Ebbetts Pass Forest Watch

July 9, 2007

SUBJECT: TIMBER HARVESTING PLAN, SOUTH RIM, THP NO. 4-06-
42/CAL 7, COMMENTS

Figure 1. South Rim THP location (boundary is approximate)

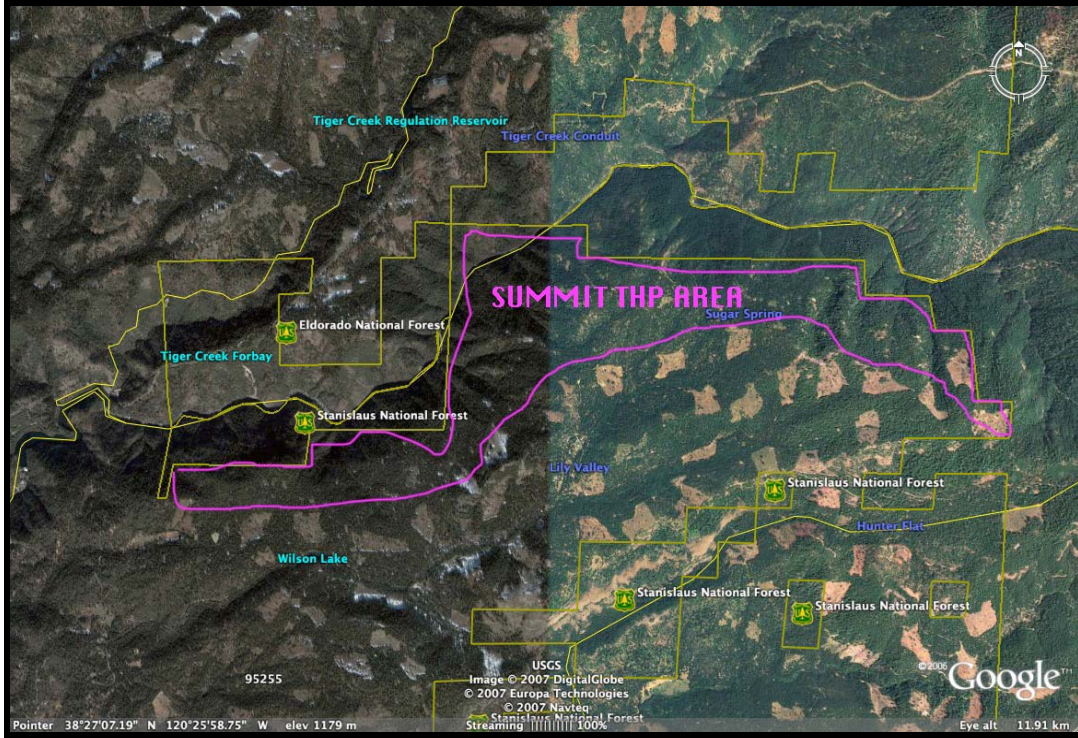
The area subject to the South Rim THP is within the boundaries of the Lower Panther Creek watershed. The area is adjacent to previously logged areas that have not reached visible regeneration and is south-west of a major burn area (Power fire and Lower Panther Creek fire). Figure 1 shows the area of the South Rim timber harvest, including the clearcuts at its southern boundary.

Figure 2. South Rim THP area and Power Fire area

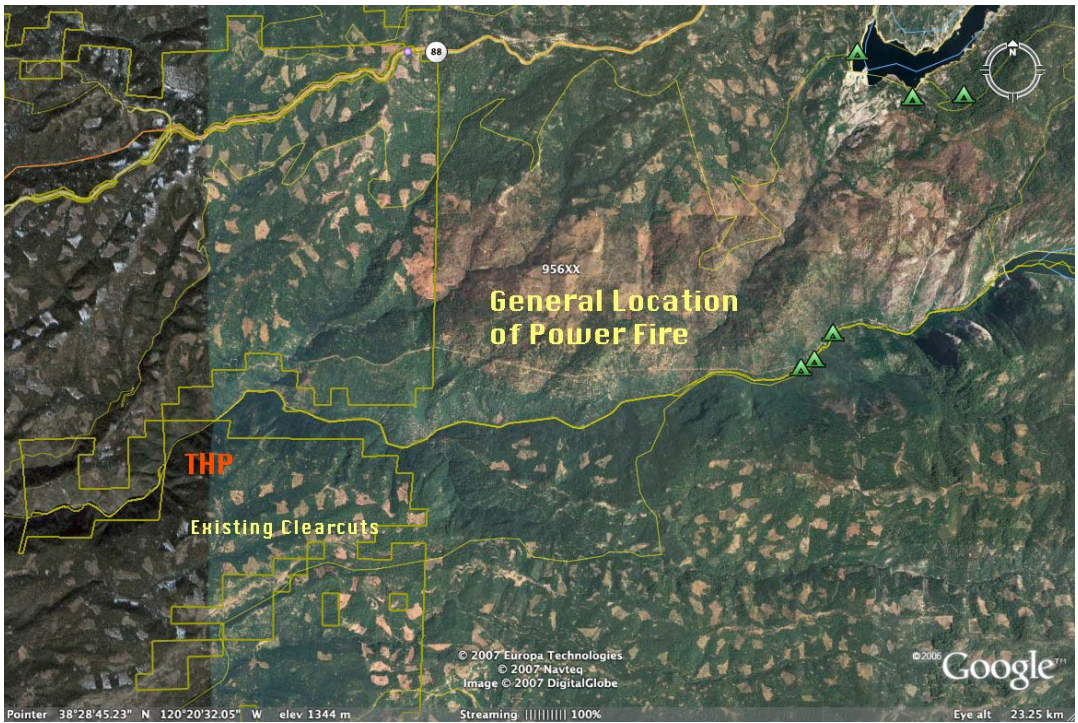
Figure 2 illustrates the relationship of the proposed THPs units to the burn area located to the Northeast of the harvest area. With the exception of limited parcels, the entire watershed has been subject to timber harvesting, with a substantial area comprised of clearcutting.
